**ACME TOWNSHIP SITE PLAN REVIEW COMMITTEE
ACME TOWNSHIP HALL
6042 Acme Road, Williamsburg MI 49690
March 14, 2018, 8:30 a.m.**

1. Site Plan Review 2018-01, Urban Diversions

Permit No.: SPR 2018-01

Request: Site Plan Review to renovate and add on to the former Chemical Bank building and to change use to an interior design and furniture sales business.

CLIENT: URBAN DIVERSIONS
PROJECT: 1712008
PROJECT MGR: JBS
ENGINEER: CPW
CAD FILE: 1712008-001
EDIT: JBS03132018
DRAWING SCALE: 1" = 10'
PLOT SCALE: 1:1, 24x36
SHEET NO. C2.0

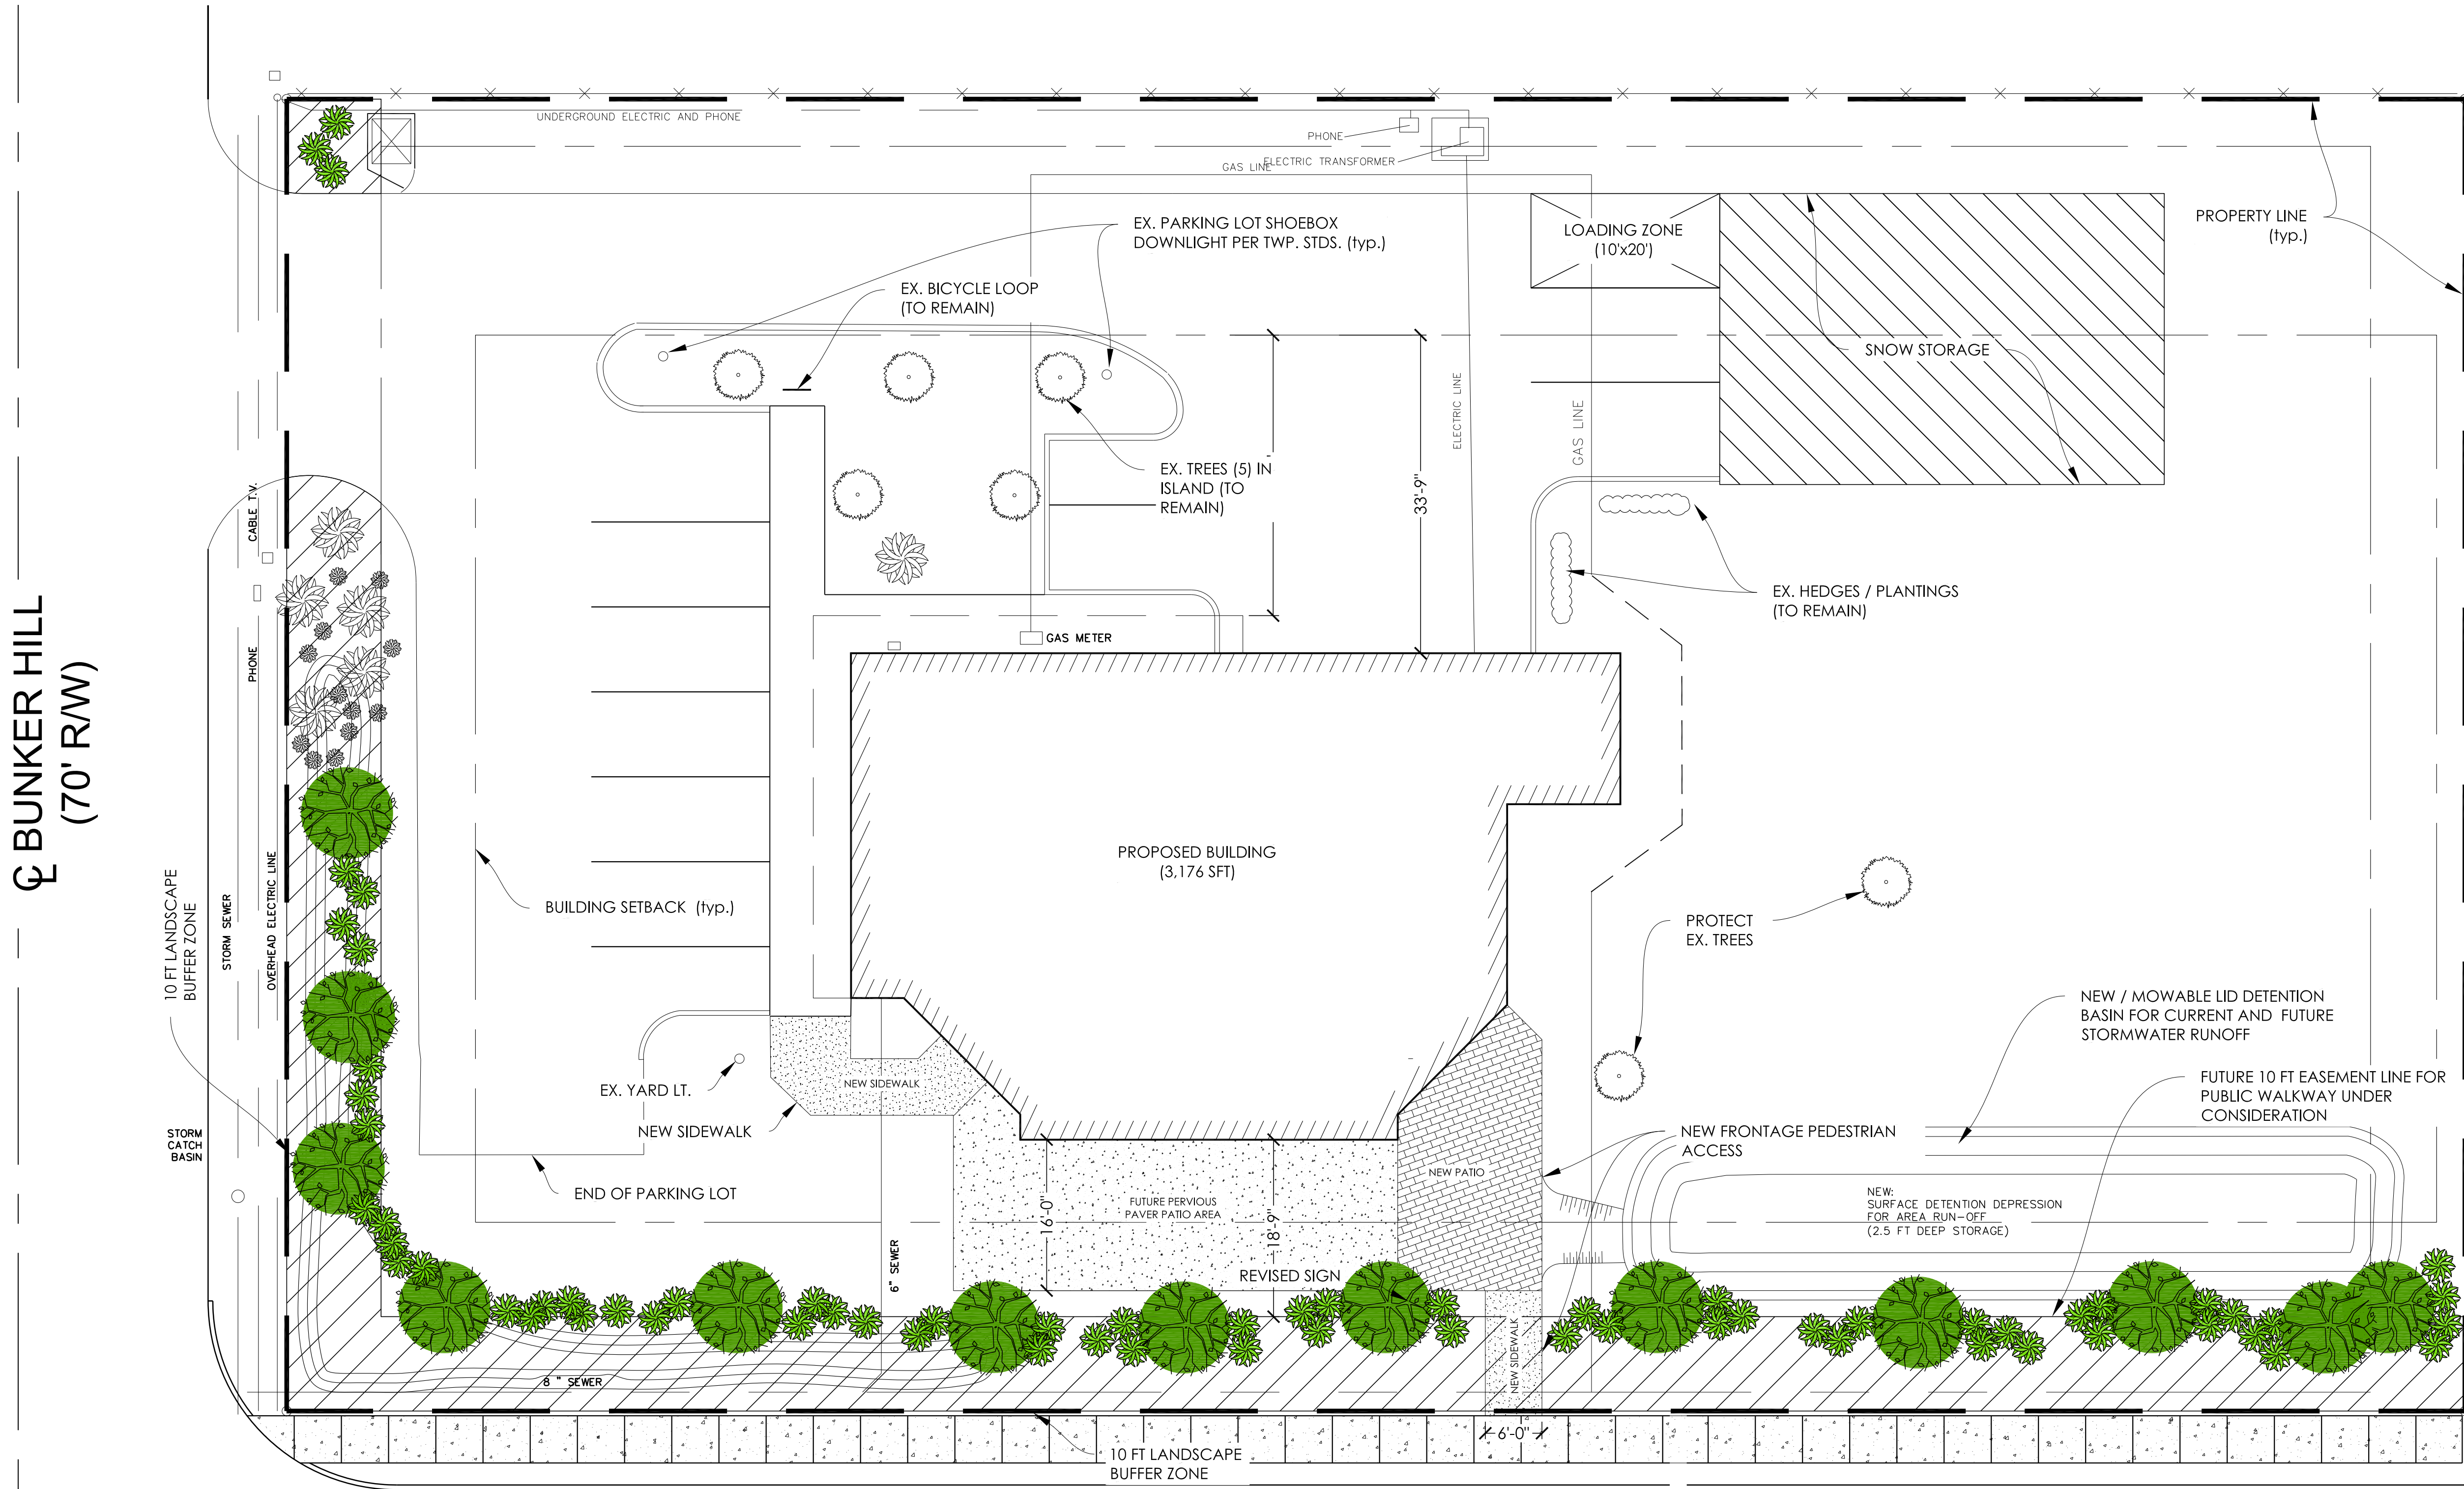
Calculations are required to show the basin drains completely within 72 hours. The calculations on the plans should be updated to reflect the maximum drain time.

The contours shown on the plans measure at a 2H:1V slope. This exceeds the side slope requirements of 3H:1V for maximum steepness.

The basin areas appear accessible for maintenance from within the site. Sediment is required to be removed from infiltration basins when it reaches a depth of 50% of the swale depth or 12 inches, whichever is less. A note needs to be included on the plan identifying that the basins will be inspected and cleaned of silt and debris each spring and fall and that the sediment will be cleaned when required.

1. Provide calculations for the maximum drain time of the basins.
2. Revise the side slopes of the basins to not exceed 3H:1V.
3. Add the maintenance note to the plans.

UPDATE - March 13, 2018: Revised plans (Rev. 4 dated 3-13-18) have been provided. The three items noted above have been addressed.

Glazing Percentage
SCALE: 1/4" = 1'-0"

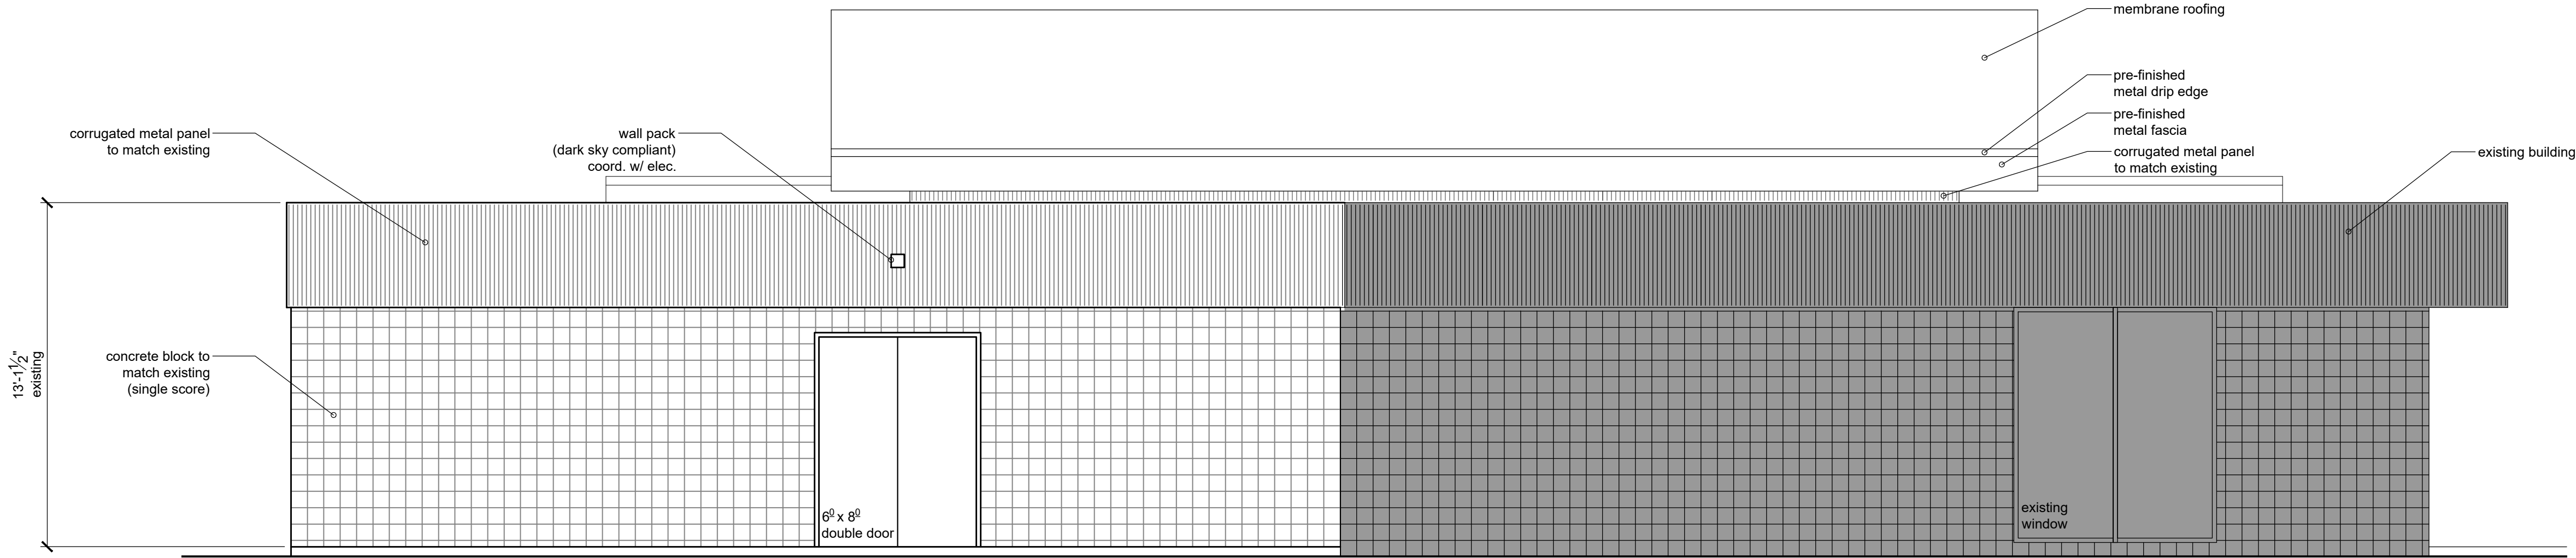
§ 6.6.6.6 Façade Components and Materials (all buildings except residential-only structures)	
Standard	Site Plan
Windows and Transparency A minimum of 75% of the ground floor story front façade between 2 feet and 8 feet above the sidewalk must be comprised of transparent, non-reflective windows into the nonresidential space.	76% transparency
Façade Ornamentation All visible elevations shall include decorative features such as cornices, pilasters, and friezes. Building recesses and protrusions will be required on larger buildings to break long uninterrupted building walls.	Brick pilasters, recesses/protrusions
Façade Massing Front façades 60 feet wide or wider shall incorporate wall offsets of at least two feet in depth (projections or recesses) a minimum of every 40 feet. Each required offset shall have a minimum width of 20 feet.	70 ft wide façade, 40 ft wide centered protrusion, angled recesses on both sides

NOTES
Glazing = 347.12 s.f.
Total s.f. between
2' & 8' = 451.48 s.f.
347.12/451.48= 76%
